Re: Work Plan and QA/QC Plan for Groundwater Investigation at El Dorado Chemical Company, El Dorado, Arkansas.

GEOLOGIC INVESTIGATION AND WELL INSTALLATION WORK PLAN

From: Randall Whitmore [RWhitmore@edc-ark.com]
Sent: Friday, November 07, 2003 12:17 PM
To: 'STUART@adeq.state.ar.us'
Subject: RE: EDCC work plan

PROPOSED BORING AND
 MONITOR WELL LOCATION MAP
 EL DORADO CHEMICAL COMPANY
 EL DORADO, ARKANSAS

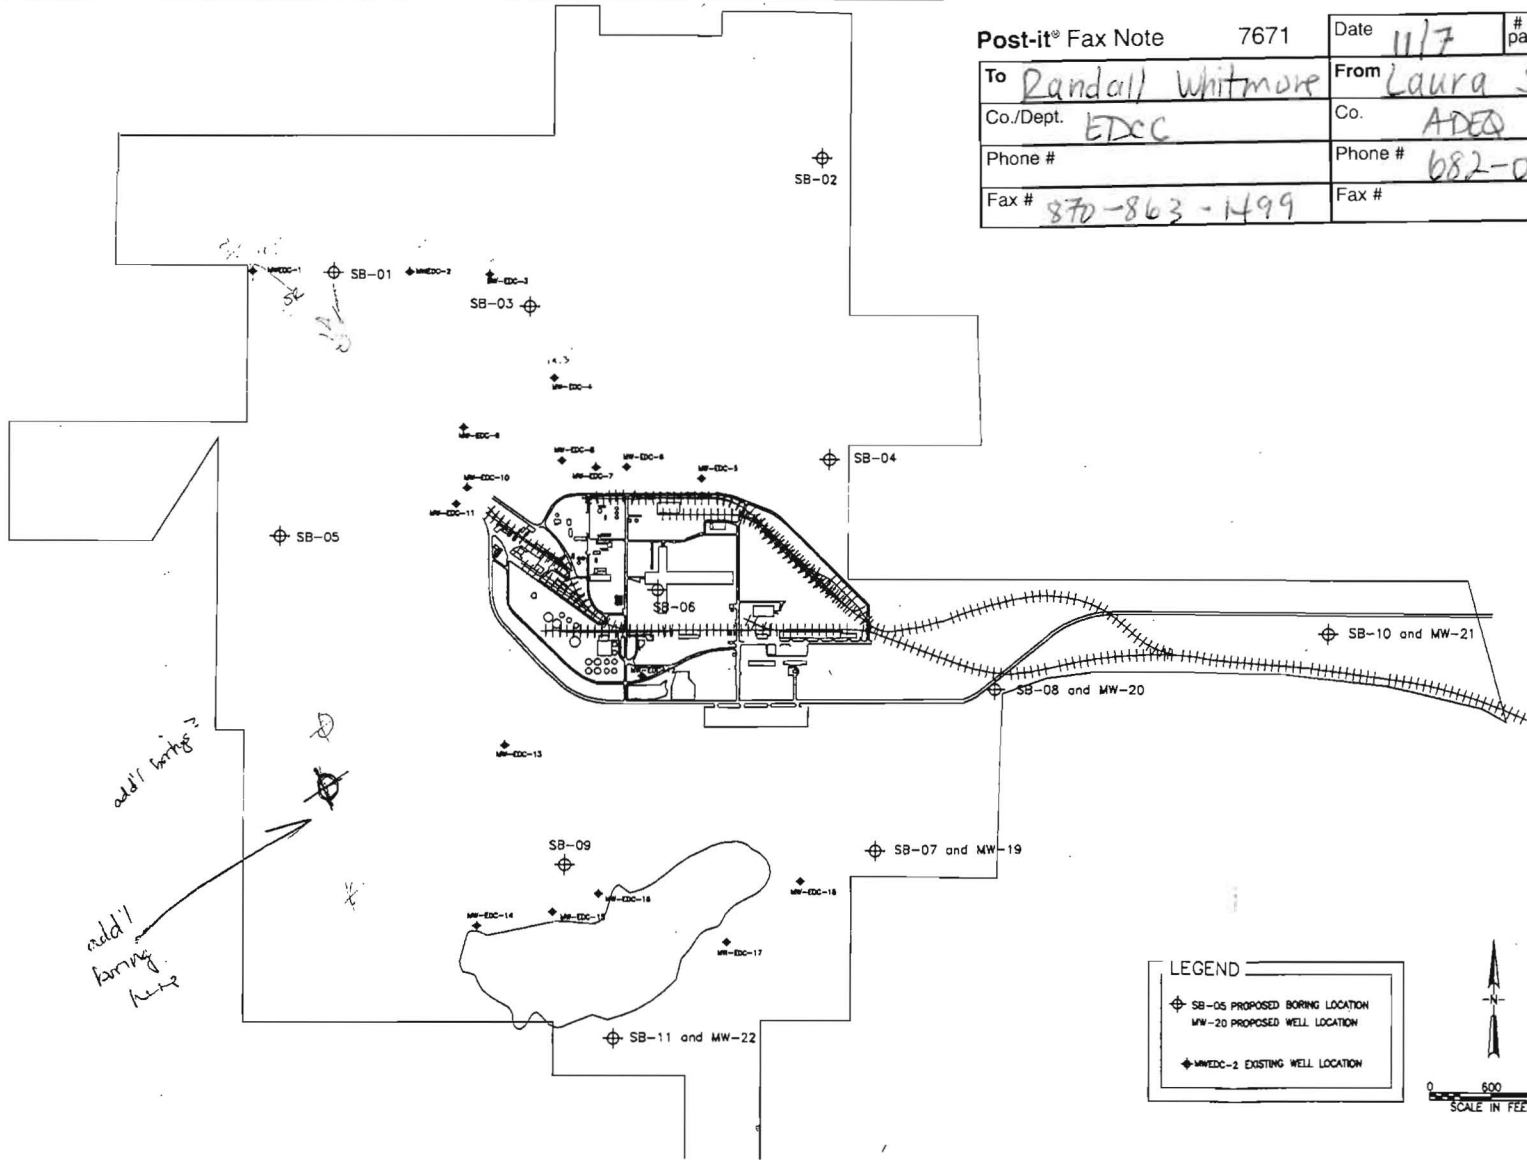
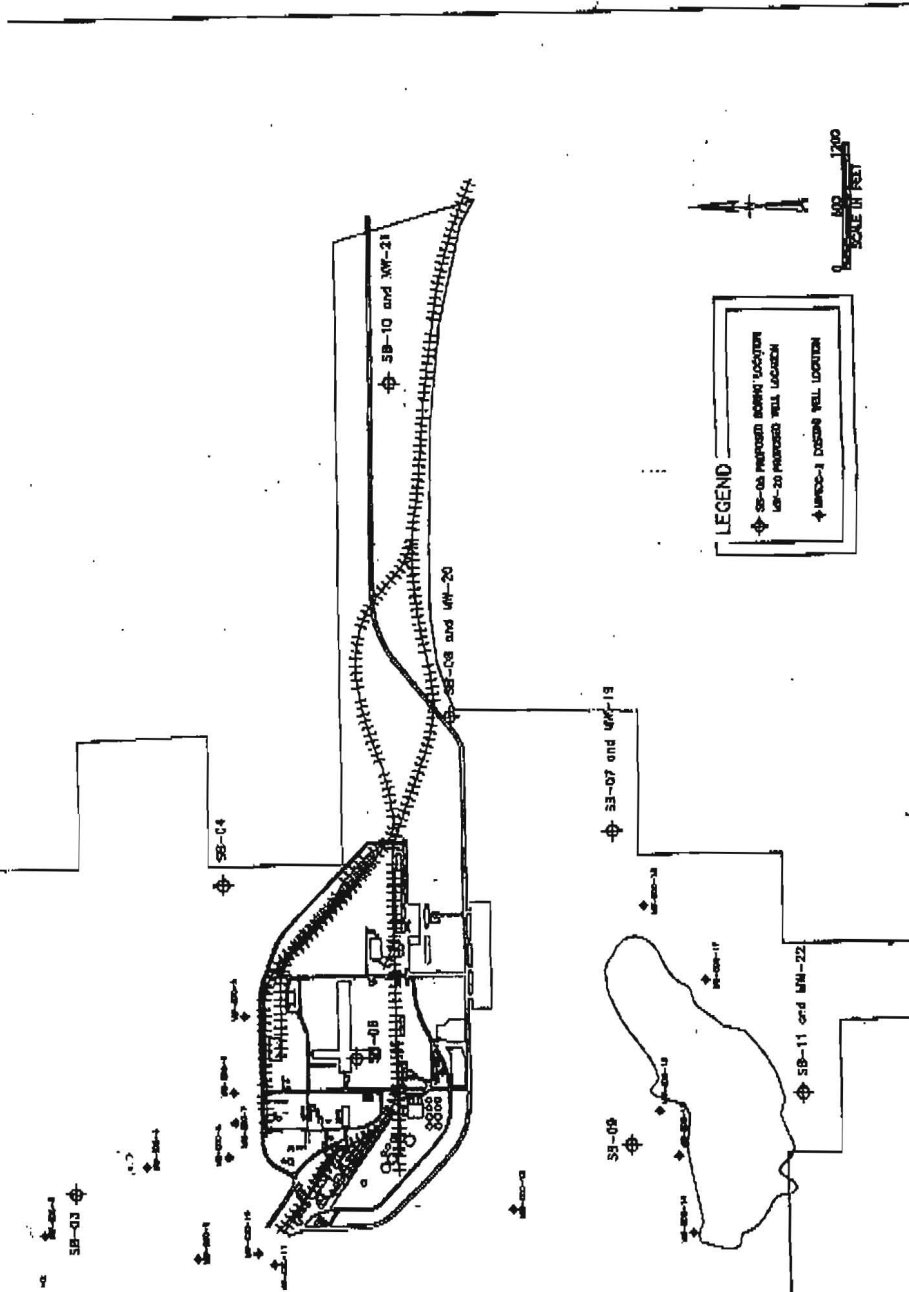
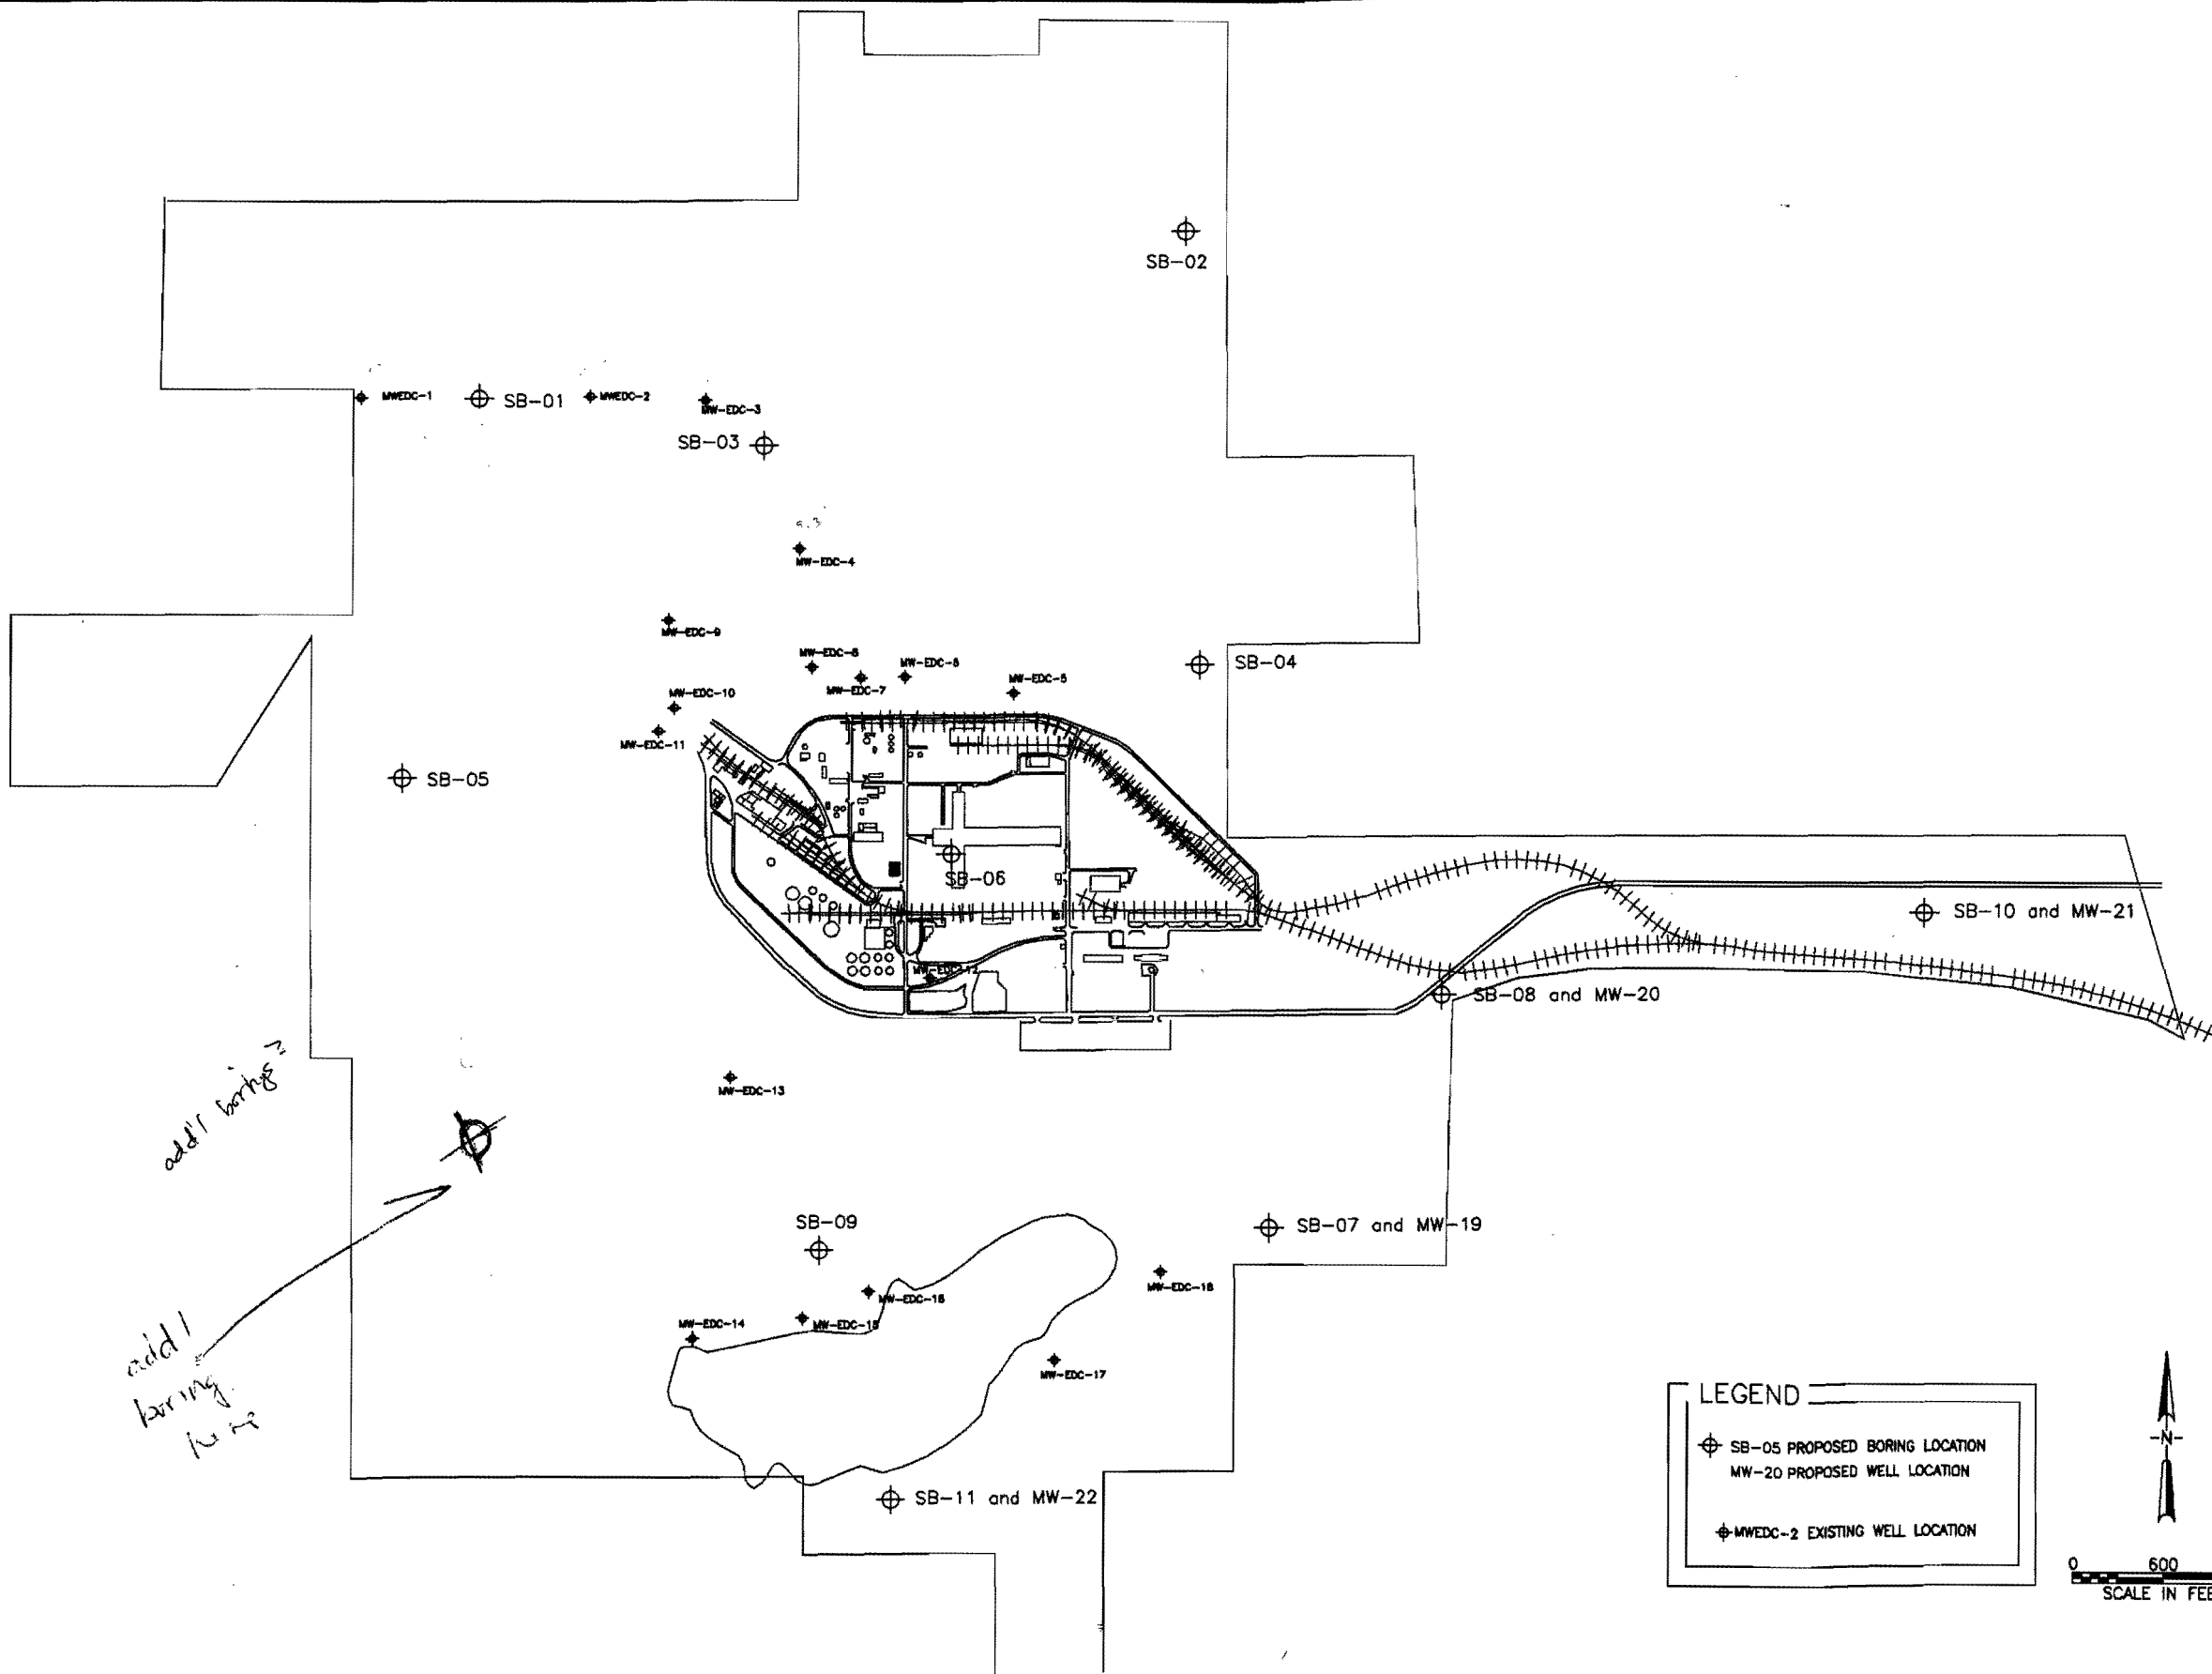
= add'l boring E of MW-EDC-13
pass boring near MW-EDC-1

I have faxed a copy of Figure 1 with a location of one additional boring. Let me know if it is illegible or isn't clear.

add 1 boring
to 2

I have faxed a copy of Figure 1 with a location of one additional boring. Let me know if it is illegible or isn't clear. [Randall Whitmore] We will add the additional boring - no problem
